UNITED STATES PATENT AND TRADEMARK OFFICE

APPLICATION NO.	FILING DATE	FIRST NAMED INVENTOR	ATTORNEY DOCKET NO.	CONFIRMATION NO	
09/874,965	06/07/2001	Mordechay Emek	109730	5925	
25944 75	90 10/21/2004		EXAMINER		
OLIFF & BERRIDGE, PLC			A, PHI DIEU TRAN		
P.O. BOX 1992 ALEXANDRIA	-		ART UNIT	PAPER NUMBER	
712274 11 (214)	., 22520		3637		
			DATE MAIL ED. 10/21/200	•

•	Application No.	Application No. Applicant(s)			
Office Action Comments	09/874,965	EMEK, MORDECHAY		D'	
Office Action Summary	Examiner	Art Unit			
	Phi D A	3637			
The MAILING DATE of this communication app Period for Reply	pears on the cover sheet with the	correspondence ad	dress		
A SHORTENED STATUTORY PERIOD FOR REPL THE MAILING DATE OF THIS COMMUNICATION. - Extensions of time may be available under the provisions of 37 CFR 1.1 after SIX (6) MONTHS from the mailing date of this communication. - If the period for reply specified above is less than thirty (30) days, a repl - If NO period for reply is specified above, the maximum statutory period - Failure to reply within the set or extended period for reply will, by statute Any reply received by the Office later than three months after the mailing earned patent term

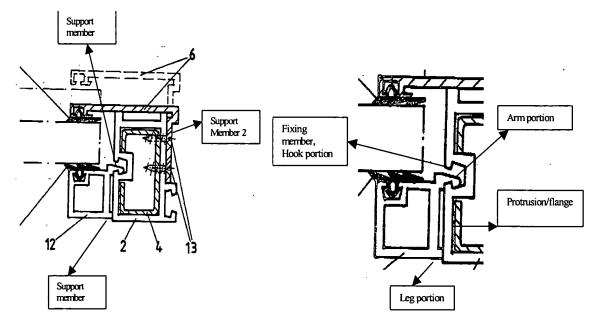
Borkoff (figures below) shows a reinforced window system comprising a first frame (2),

the first frame being provided with a plurality of fixing members distributed on an inside perimeter of the first frame, a second frame (12, 6) which is separate from the first frame and is removably installable therein, the second frame carries a reinforced window pane secured within

the second frame, the second frame being provided with a plurality of support members distributed on an outside perimeter of the second frame to face the fixing members of the first frame and to support the second frame when the support members are in engagement with the fixing members, at least some of the fixing members being provided with a securing means (13) for securing a position of the second frame within the first frame, at least some of the support members (support member 2 above) are removably attached to the outside perimeter of the second frame, the support members being configured as bifurcated members having a leg portion attachable tot eh second frame and an arm portion, extending toward the fixing members of the first frame and engageable therewith, said arm portion comprising a first arm and a second arm (the parts that form the arm portion), the securing means (13) comprising a fixation screw adapted to bear against a corresponding arm portion of the support member, the support members being fixed at their locations to the second frame, the window pane is fixed to the second frame by a mechanical glazing system, fitted with resilient gaskets at both faces of the window frame, the window pane sealingly bears against the first, a resilient sealing member being fitted between an outside face of the window pane and the first frame (indirectly), the system being adapted to be fitted behind an existing window system installed in the wall opening (inherently capable of being adapted to do so), a width dimension defining the support members and the adjacent support members being provided with different dimension, the system being a fool-proof system whereby the fixing members of the first frame and the corresponding support

some of the support members of the second frame absorb energy associated with a shock wave that strikes the window pane (inherently capable of doing so).
